**SOLICITATION AMENDMENT
MODIFICATION DE L'INVITATION**

Title - Sujet Data Remediation and Marking RFP	
Solicitation No. - N° de l'invitation W6381-170008/D	Amendment No. - N° modif. 005
Client Reference No. - N° de référence du client W6381-170008	Date 2020-05-10
GETS Reference No. - N° de référence de SEAG PW-\$\$XG-624-37464	
File No. - N° de dossier 624xg.W6381-170008	CCC No./N° CCC - FMS No./N° VME
Solicitation Closes - L'invitation prend fin at - à 02:00 PM on - le 2020-05-26	Time Zone Fuseau horaire Eastern Daylight Saving Time EDT
F.O.B. - F.A.B. Plant-Usine: <input type="checkbox"/> Destination: <input checked="" type="checkbox"/> Other-Autre: <input type="checkbox"/>	
Address Enquiries to: - Adresser toutes questions à: NGUYEN, Mark Nam	Buyer Id - Id de l'acheteur 624xg
Telephone No. - N° de téléphone (343) 550-1613 ()	FAX No. - N° de FAX () -
Destination - of Goods, Services, and Construction: Destination - des biens, services et construction: 105 HOTEL DE VILLE GATINEAU QC J8X 4H7 CANADA

Solicitation Amendment 005 is raised to:

APPENDIX 1: CONCEPT OF OPERATIONS (revised) circa 2025

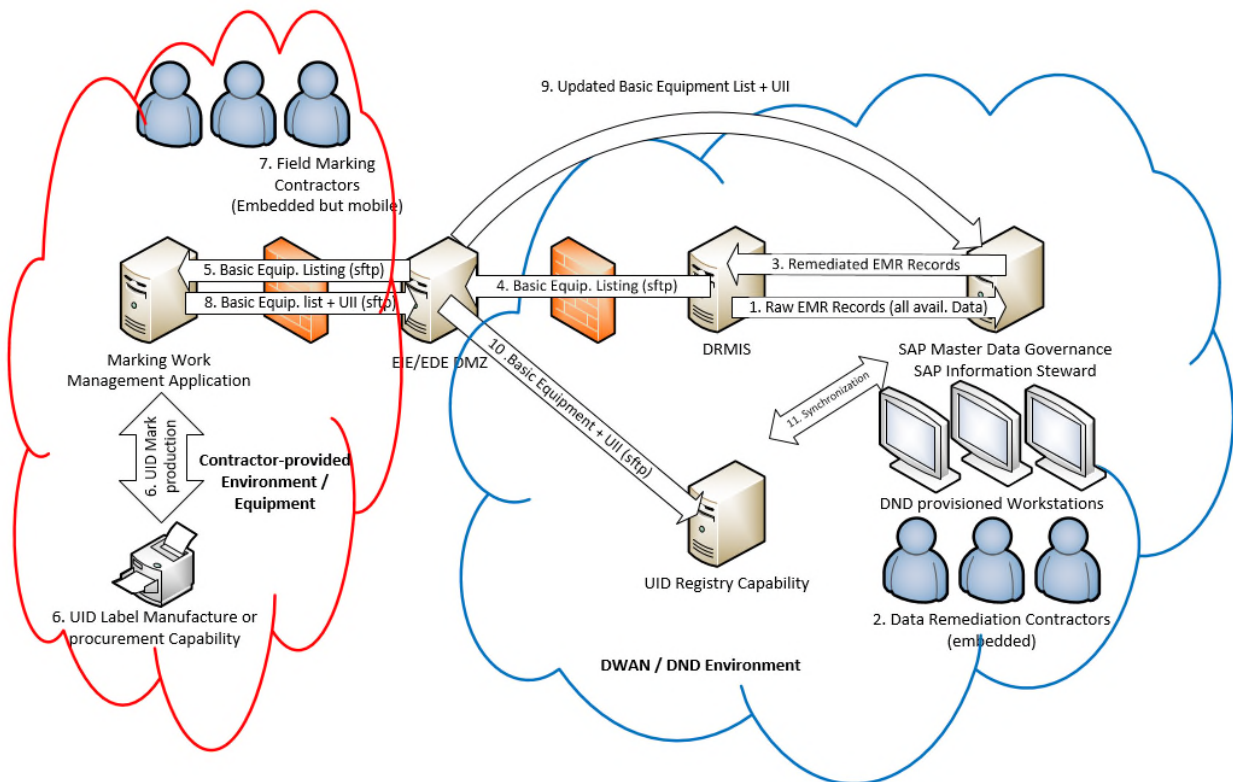
C. At Appendix 1: Concept Of Operations:

DELETE: Appendix 1: Concept Of Operations in its entirety

REPLACE BY: "APPENDIX 1: CONCEPT OF OPERATIONS (revised) circa 2025"

Activity Detail and Sequence of Events

1. EMR records for Equipment tasked for data remediation are coordinated with Data Remediation Contractors.

DND may provide access to the following tools on site circa 2025: SAP Master Data Governance (MDG) & SAP Information Steward (IS).

2. Data Remediation Technicians correct, augment, merge, enrich EMR records according to equipment specific business rules developed in concert with DND Central Data Managers and the respective DND Data Owner, using DND provided tools.

Corrections are subject to data owner approval via DND Data Governance Process (expected to be MDG in 2025) prior to promotion/replication to DRMIS production system.

3. Cleansed & approved EMR record data is now live in DRMS production environment.

4. Subset of cleansed EMR data (EMR number, CAGE, MPN, MSN) for items tasked for marking is exported from DRMS to EIE. Only data required to execute specific Task Authorizations is exported.

5. Contractor retrieves basic item data for Task Authorization which includes locations, item types, and individual items to be marked under that specific Task Authorization.

6. Contractor supplies UID Labels to meet requirements of Task Authorizations; provides Direct Part Marking tools as leased/purchased by DND.

7. Contractor provides appropriate information to Field Marking Contractors to perform physical reconciliation and to track the application of UID Labels and UID Direct Part Marks to items; produces UII packaging labels and applies them to unit, intermediate, and exterior containers; captures item pictures as tasked; logs "found" equipment and other exceptions.

8. Resultant data captured during field activities against a Task Authorization (including exceptions, found items, data errors, successfully marked items, etc.) is sent back to DND via EIE.

9. Proposed EMR record updates are loaded into EMR data governance process for DND approval; these item reconciliation updates are related to data that can only be captured in the field during the marking

process, and includes updated item locations, UII assigned to each item, proposed creation of any new EMRs for found items, and additional information captured as required.
10. Resultant of field activities used to populate Interim UID Registry.
11. UID registry passes MDG, UII attribute (using EMR no. and/or CAGE+MPN+MSN as key).
